**Request for Additional Information No.569,
Questions 06.02.02-136 through 06.02.02-139**

U.S. EPR Standard Design Certification

Docket No. 52-020

SRP Section: 06.02.02 – Containment Heat Removal Systems

Figure 2.2.2-1—In-Containment Refueling Water Storage Tank System Functional Arrangement
Sheet 1 of 3

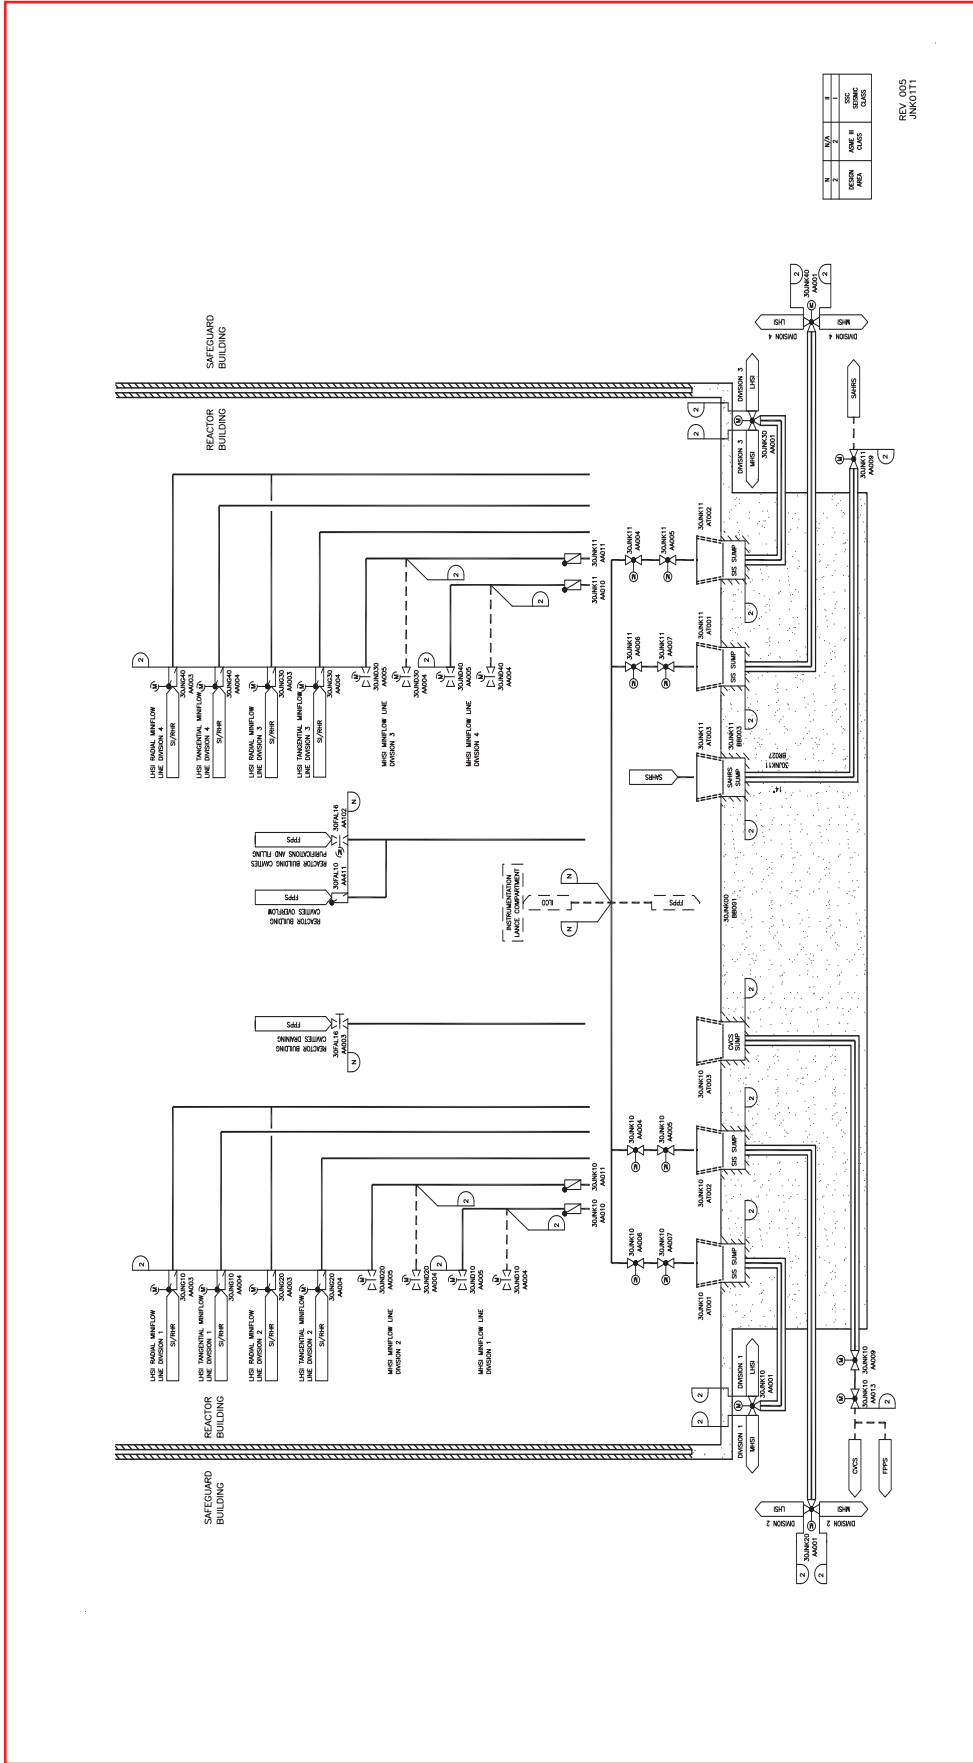
All the valves in Technical Report ANP-10293, Table G.2-1, Components in the ECCS Flow Path during an LBLOCA,” do not appear to be listed in DCD Tier 1 Table 2.2.3-1, “SIS/RHR Equipment Mechanical Design.” Since ITAAC 3.1 in DCD Tier 1 Table 2.2.3-3 concludes that ECCS pumps and valves in Tier 1 Table 2.2.3-1 are functionally designed and qualified under design basis accident conditions, then all pumps and valves in the ECCS flow path during SBLOCA and LBLOCA operations should be listed in the Tier 1 Table 2.2.3-1. Staff requests AREVA to ensure that all valves in the ECCS flow path are identified in Tier 1 Table 2.2.3-3 or provide justification why the valves should not identified in this table.

U.S. EPR FSAR Tier 1, Table 2.2.3-1—SIS/RHRS Equipment Mechanical Design, and Table 2.2.2-1—IRWSTS Equipment Mechanical Design, will be revised to include valves listed in Technical Report ANP-10293, Table G.2-1, “Components in the ECCS Flow Path during a LBLOCA.”

Conforming changes related to these valve additions will be made to U.S. EPR FSAR Tier 1, Section 2.2.2, Item 3.2, Table 2.2.2-3—In-Containment Refueling Water Storage Tank System ITAAC, Figure 2.2.2-1—In-Containment Refueling Water Storage Tank System Functional Arrangement, Figure 2.2.3-1—Safety Injection System and Residual Heat Removal System Functional Arrangement, and U.S. EPR FSAR Tier 2, Table 3.2.2-1—Classification Summary.

U.S. EPR FSAR Tier 1, Section 2.2.2, Item 3.2, Table 2.2.2-1, Table 2.2.2-3, Table 2.2.3-1, Figure 2.2.2-1, Figure 2.2.3-1, and U.S. EPR FSAR Tier 2, Table 3.2.2-1 will be revised as described in the response and indicated on the enclosed markup.
